SERVICE BULLETIN

B-071

2008 1125R CALIBRATION AND STARTER SOLENOID PRODUCT PROGRAM 0502

Figure 1. Starter Solenoid Cable Fasteners

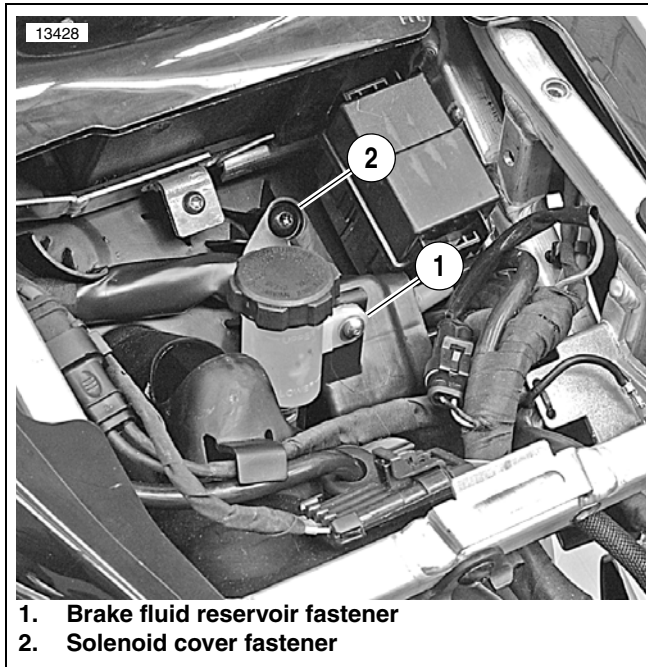
This bulletin also communicates an updated starter solenoid fastener torque procedure to improve battery cable retention and circuit integrity.

- Remove the seat.
- Disconnect negative battery cable.
- See Figure 1. Remove the brake fluid reservoir fastener (1).
- Remove solenoid cover fastener (2) and the cover.
- See Figure 2. Remove starter solenoid cable fasteners (4) and washers.
- Apply blue Loctite 243 (blue) to the fasteners (4).
- Install starter solenoid cable nuts and tighten to 43-48 in-lbs (4.8-5.4 Nm).

8. See Figure 1. Install solenoid cover and fastener (2). Tighten fastener to 37-60 **in-lbs** (4.1 to 6.8 Nm).
9. Install brake fluid reservoir and fastener (1) and tighten to 32-36 **in-lbs** (3.6-4.1 Nm)
10. Connect negative battery cable.
